DEVELOPMENT REVIEW BOARD  
SUPPLEMENTAL SUBMITTAL

PROJECT NO. PR-2021-005390  
Application No. SI-2021-00832 and VA-2021-00217

**Re:** Hiland Plaza Comment Responses and Supplemental Information (PR-2021-005390)

HILAND PLAZA

**C-102**

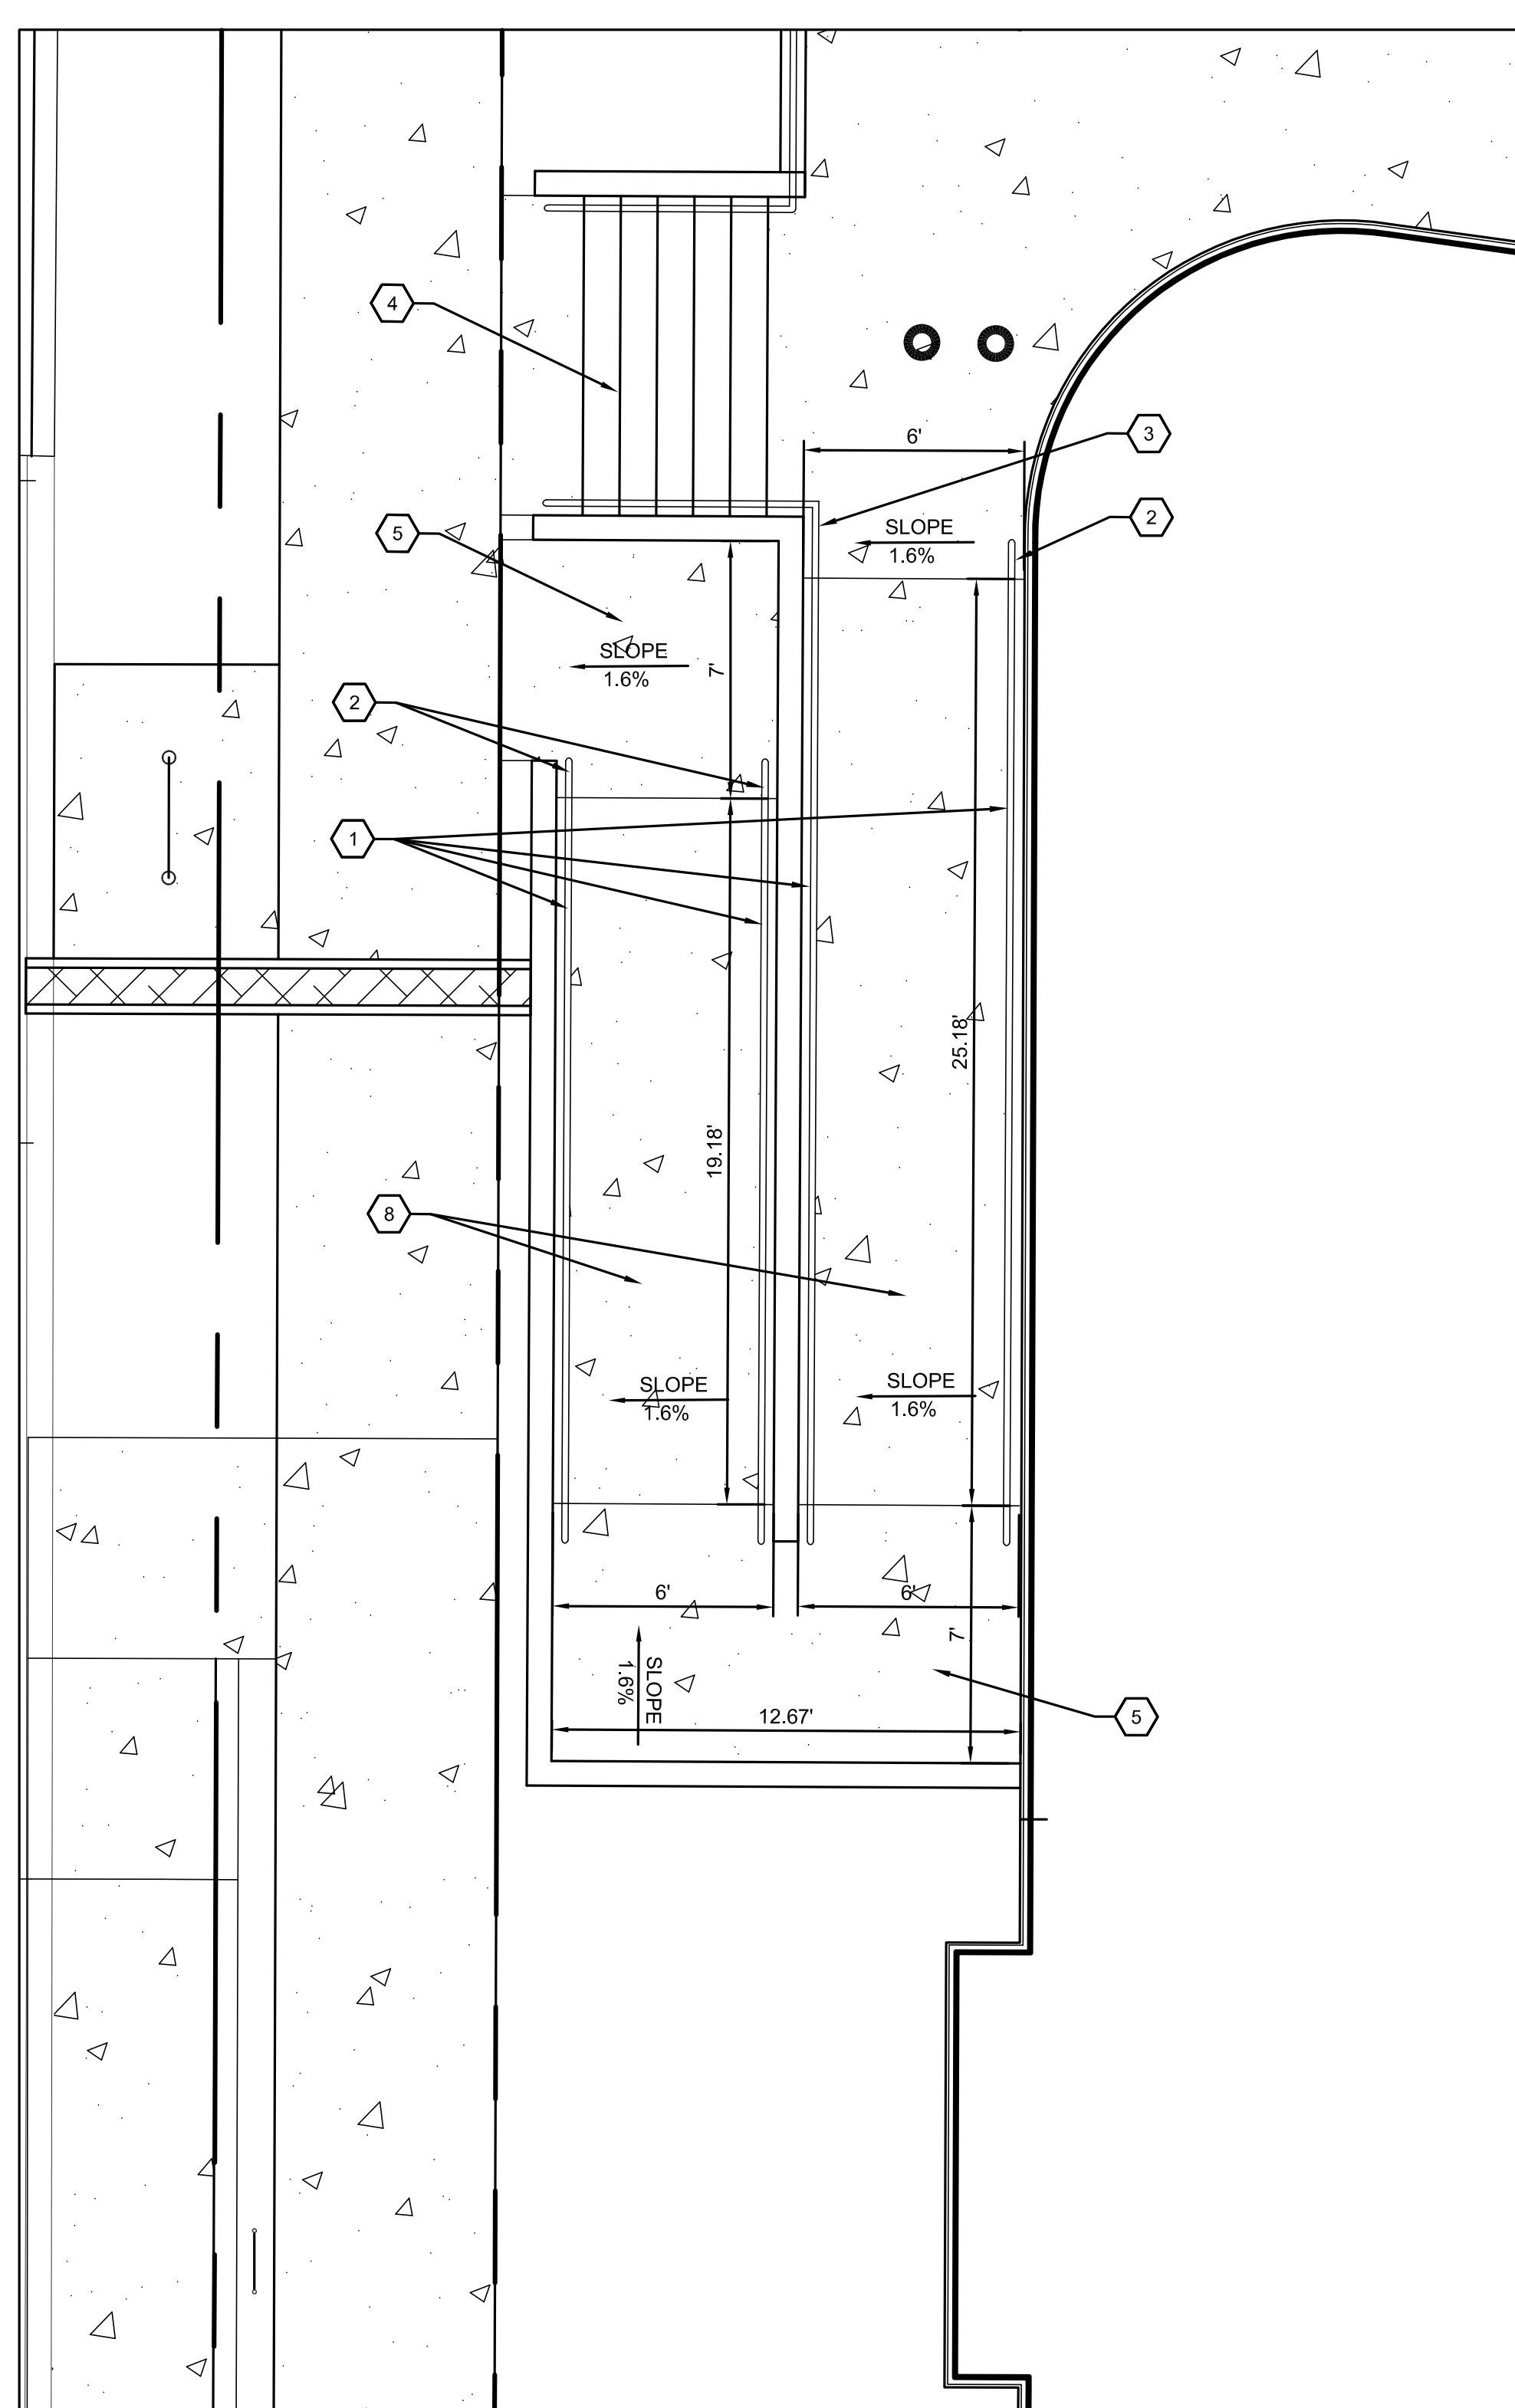
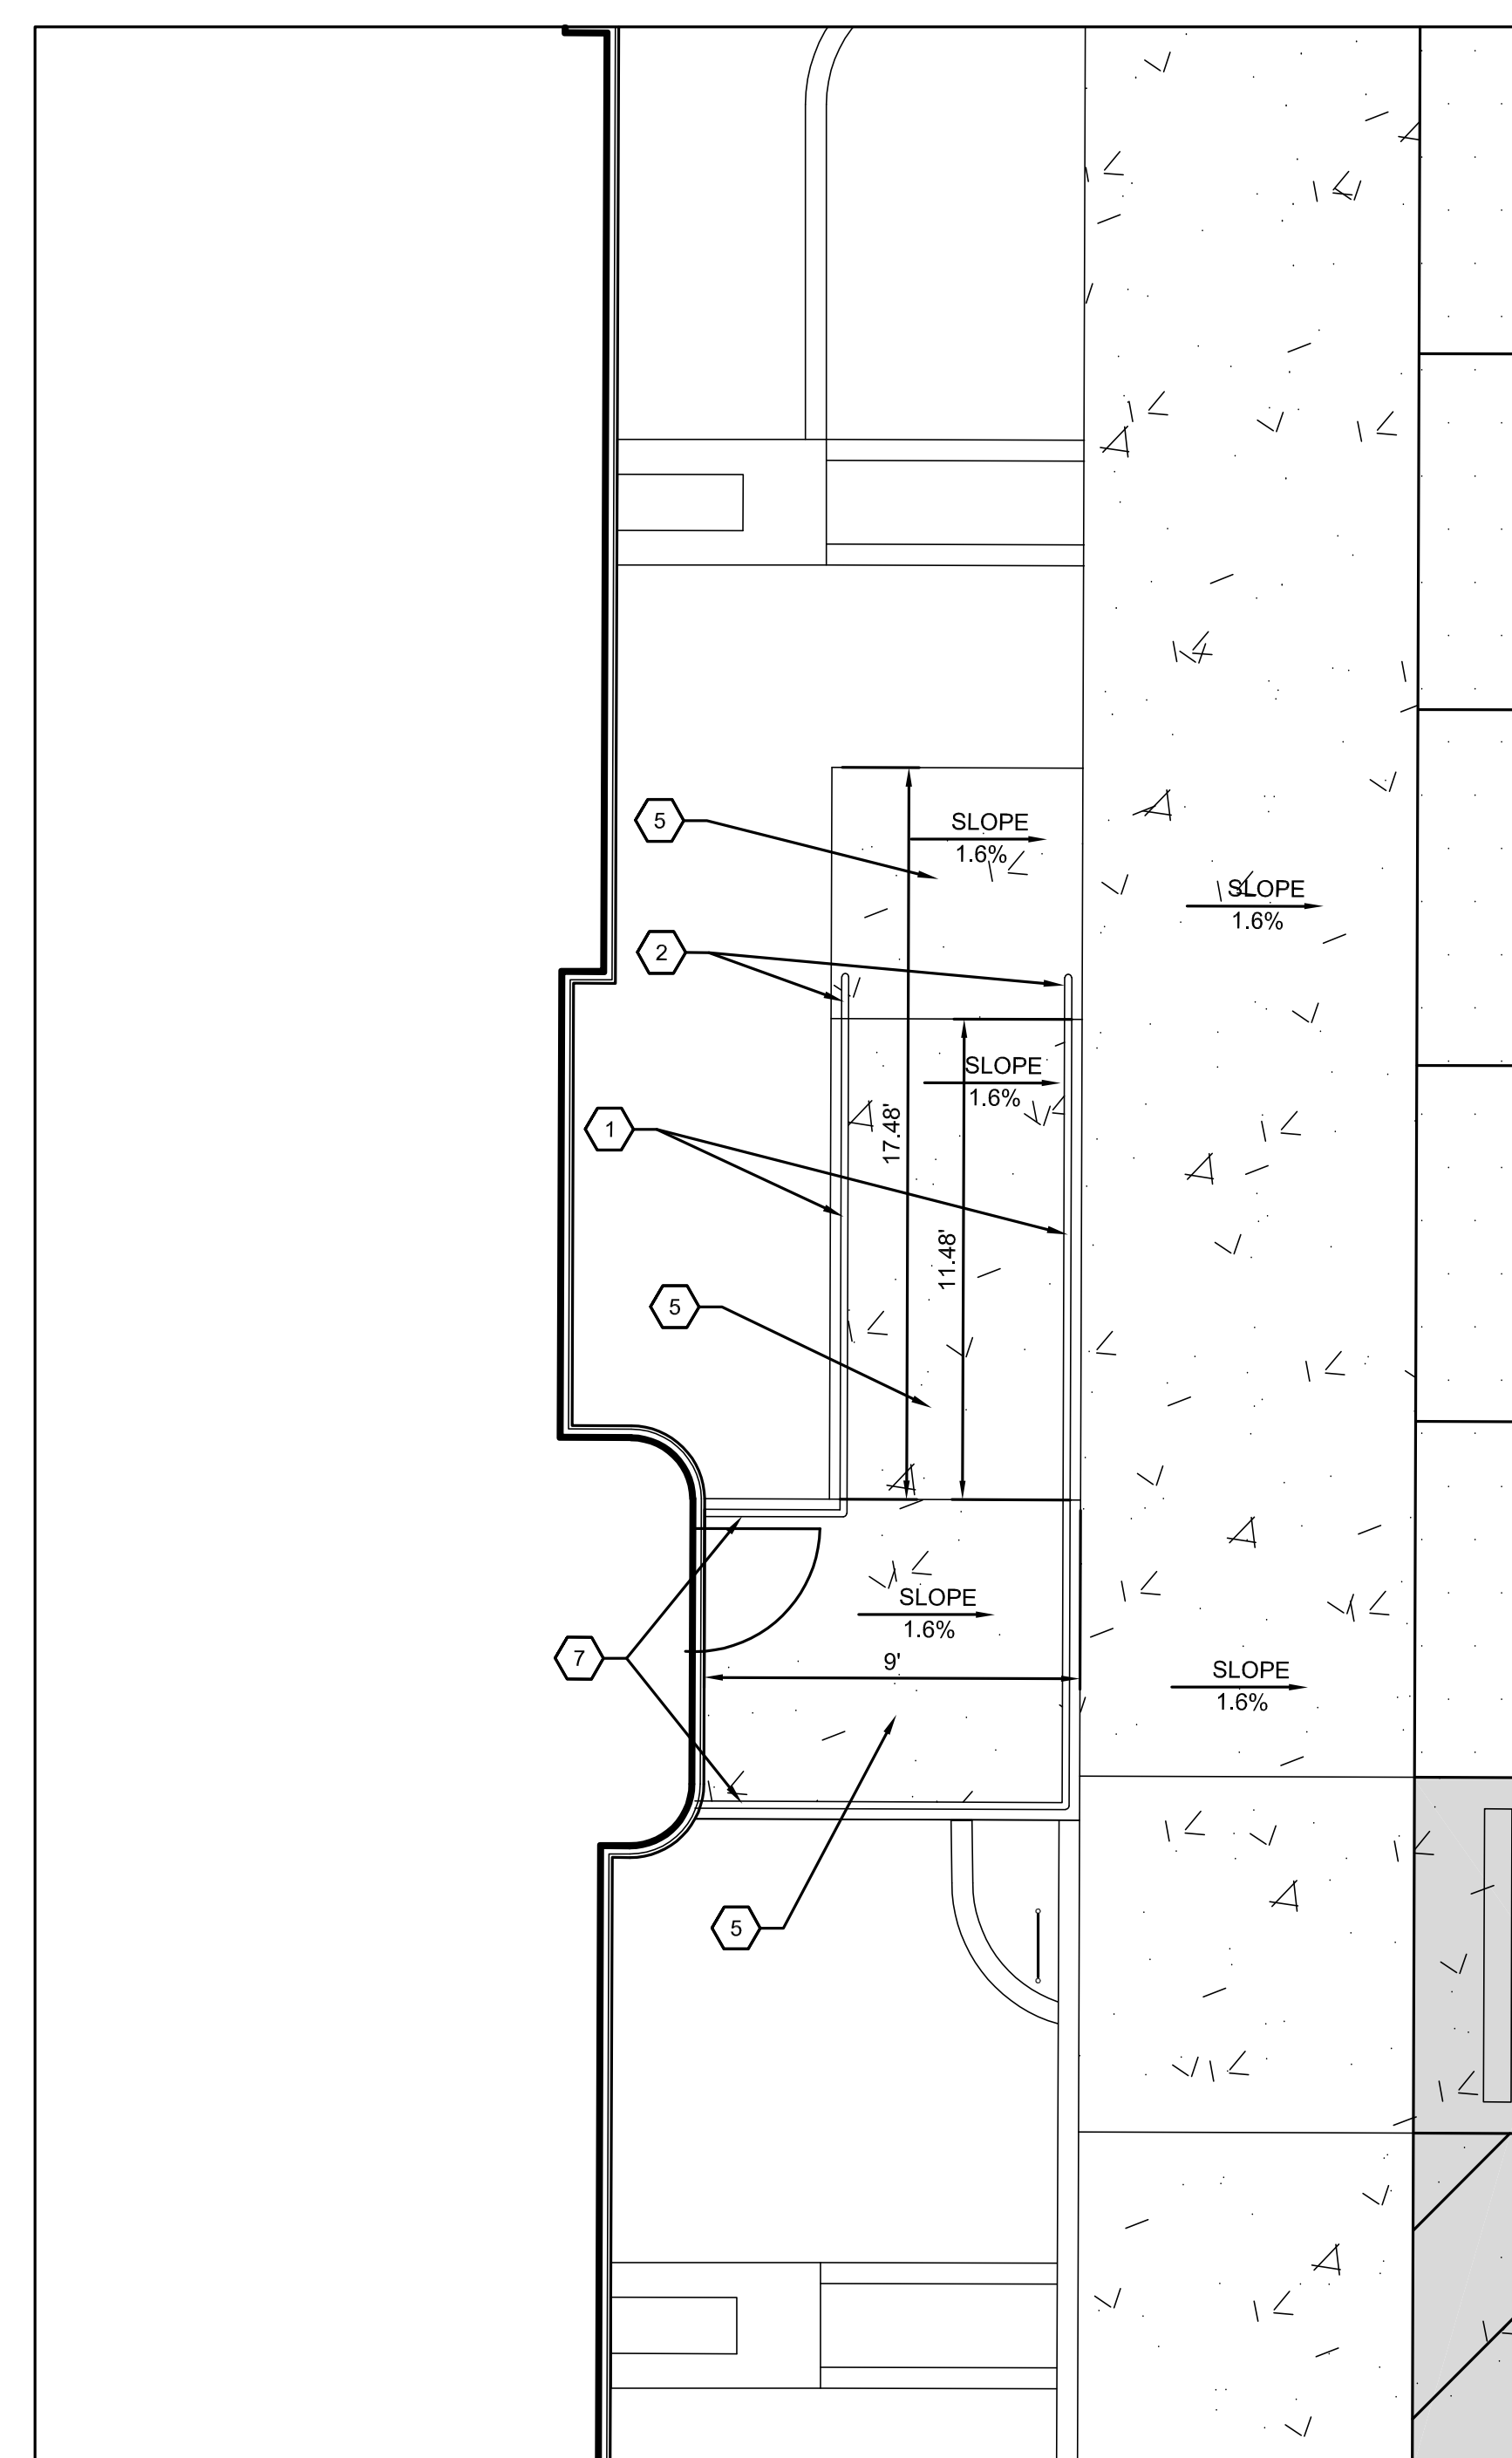
3. Specify which ramps are being used around the handicapped spaces since the turndown sidewalk detail specifies a vertical separation between the pavement and the sidewalk.

6. Provide complete detail for the ramp along the east side of the building with the handrail, showing all dimensioning. (The handrail detail provided is for the stair ramps.)

- a. Enlarged plans of ramps have been added on sheet C-102.*
4. For the corner ramp at the northwest corner, have it line up with the crosswalk, and show existing crosswalk. Drawing 2441 is more appropriate to use than Drawing 2442 in this case.

- a. Enlarged plans of ramps added on sheet C-102.*
7. Sidewalk detail shall call out a maximum 2% slope.
  - a. Note added.*
8. Clear sight is a concern with the parallel parking, particularly looking to the left when pulling out of the entrance. Further analysis of this may result in a few parallel parking spaces being eliminated. Also provide distance between centerline on Silver and parallel parking.

**D3** TREE PLANTING DETAIL  
 SCALE: NTS

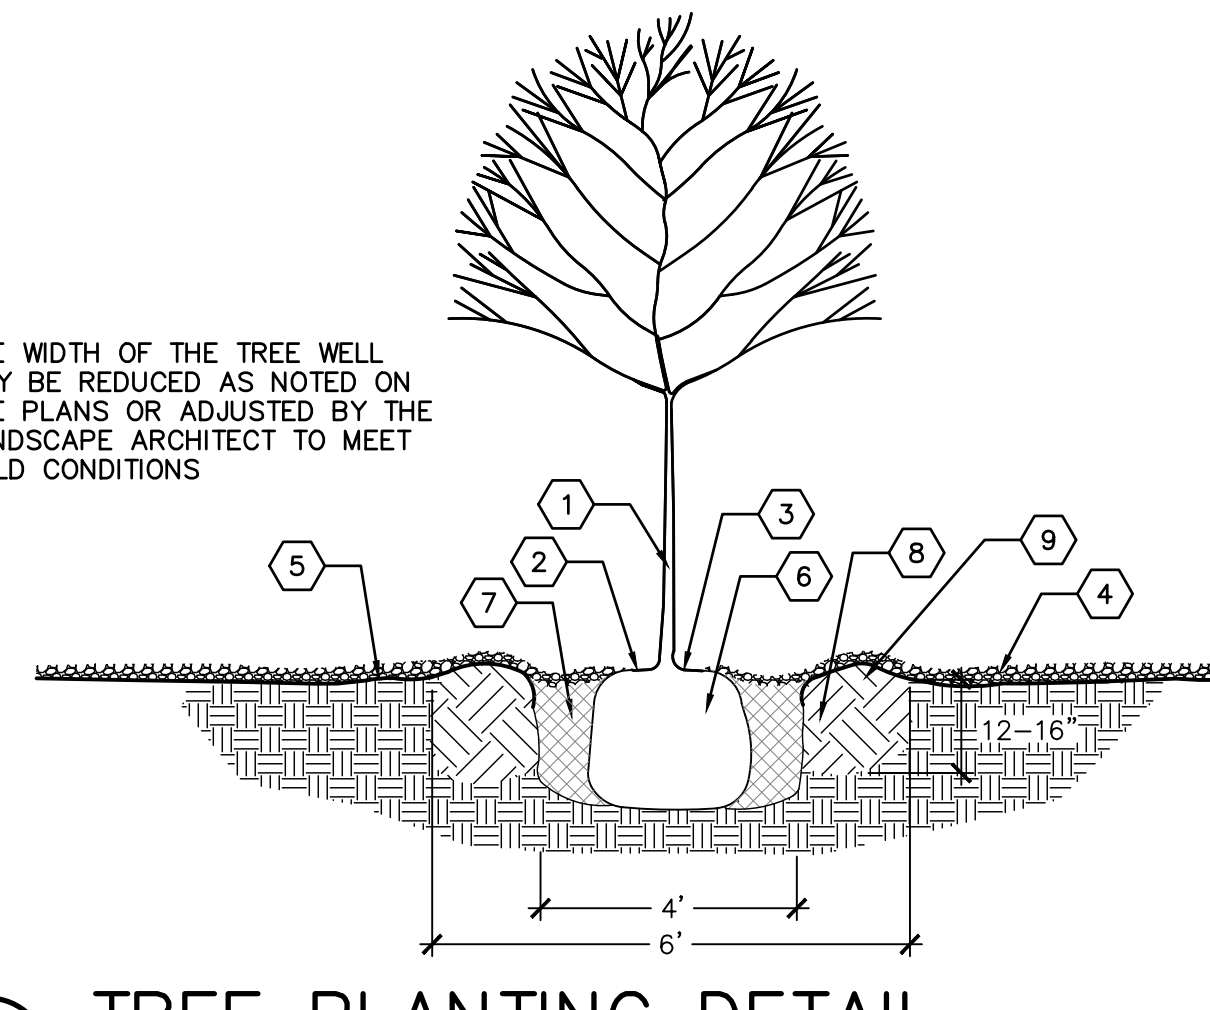
1. Please add note under tree planting detail per IDO section 5-6(C)(5)(e). Such as or similar: "Install organic wood chip mulch over rootball and to cover dripline. Generally, mulch should be held 4" back from tree trunk."
  - a. Construction Note #2 on the tree planting detail references this requirement.*

**C5 PATIO HANDRAIL**  
 NOT TO SCALE

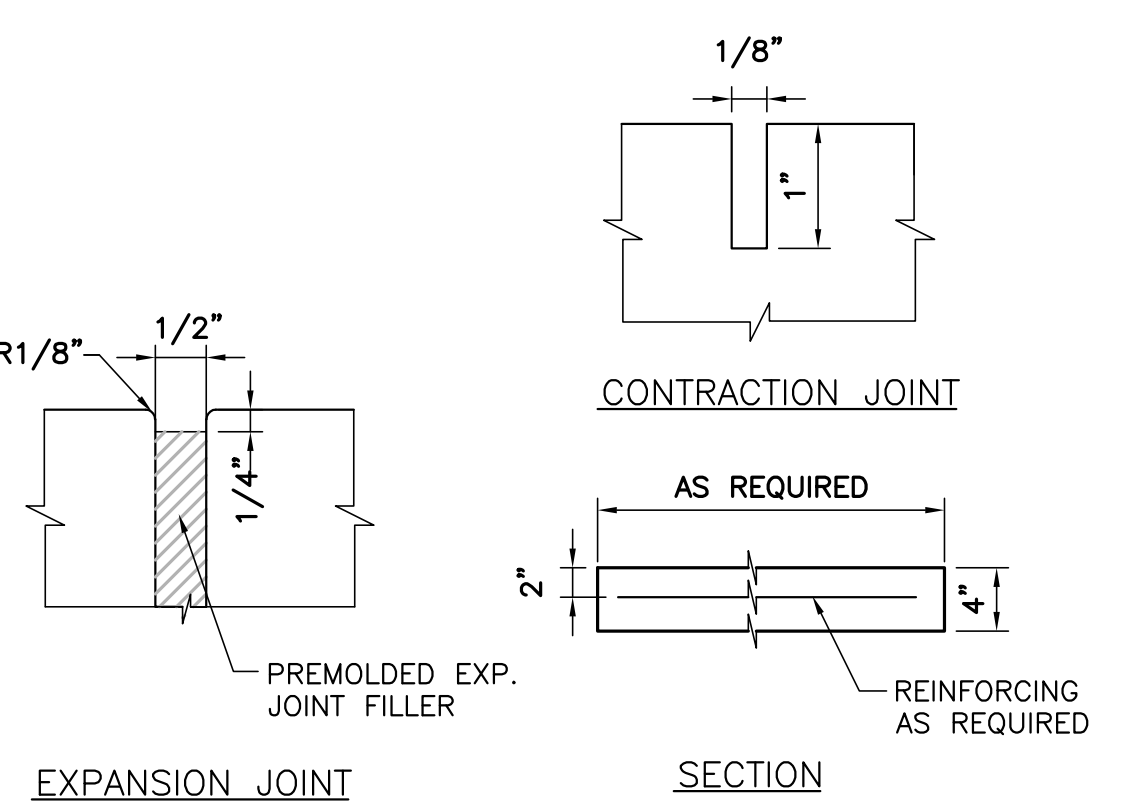
A potential Deviation to the wall and fence height was discussed at the July 21, 2021 DRB meeting for the railing at the patio on the northeast corner of the site. Upon further review, this railing does extend into the street side yard on Jackson Street where height is limited for mixed-use to 3 feet in height. In addition, since this project is a mixed-use development rather than a strictly multi-family development it does not appear to qualify for the exception in IDO Section 5-7(D)(3)(c) that otherwise allows a 6-foot-tall fence when utilizing view fencing. As such, we are requesting approval of a Deviation of 6 inches as allowed in Table 6-4-1 Allowable Deviations with the following justification:

*Applicant Response: The subject site includes site constraints not generally shared by the surrounding development, including its location on a corner lot and the grading required to create the proposed building pad and patio space where the railings are located. To the south of the patio, the grading slopes upward to the building pad, which pushes the residential unit entries to the east and thus extends the width of the street side yard area. This area is being utilized for landscaping purposes. If the building could be placed closer to Jackson Street, the street side yard would be minimized, and potentially this deviation would not be necessary because fences in other locations of the property are allowed to up to 8 feet tall. Compounding this matter, is a grade separation between the sidewalk and patio, which requires the developer to provide a railing at the specified height. This is for safety reasons and prevents someone from falling over the small ledge that is being created.*
